DE LOREAN MOTOR COMPANY

# SERVICE BULLETIN

NUMBER ST-01-6/81

SUBJECT: LUGGAGE COMPARTMENT COVER FINISHING MOLDINGS  
SERVICE ACTION SA 0001

## LUGGAGE COMPARTMENT COVER FINISHING MOLDINGS

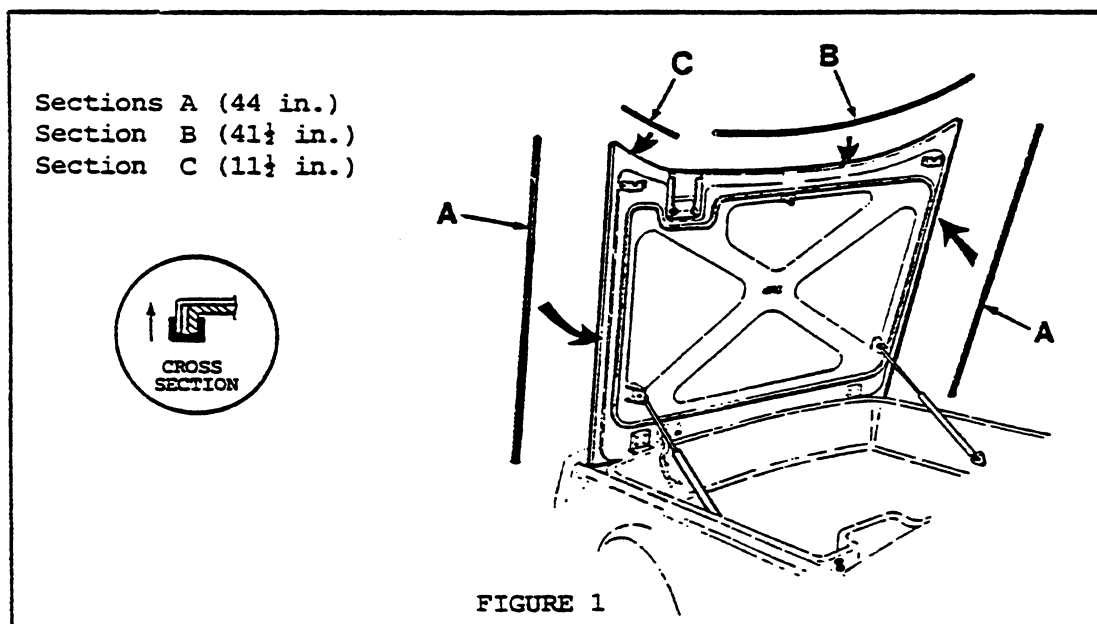
These moldings must be installed on the luggage compartment cover of all De Lorean vehicles not so equipped according to the instructions on the reverse side.

1. Raise luggage compartment cover and cover fenders.
2. Using a knife or other suitable tool, cut the supplied molding material as follows:

- A. Two (2) sections 44 inches long
- B. One (1) section  $41\frac{1}{2}$  inches long
- C. One (1) section  $11\frac{1}{2}$  inches long

NOTE: Cuts should be 90° square cut. Do not stretch material while measuring.

3. Apply a thin bead of 3M clear Emblem Adhesive (3M Part No. 08061) into the groove of the cut section of molding material prior to installation.
4. With adhesive applied, position the molding sections over the folded outer edge of the stainless steel panel and over the outer lip of the cover's plastic inner panel as indicated below in Figure 1.
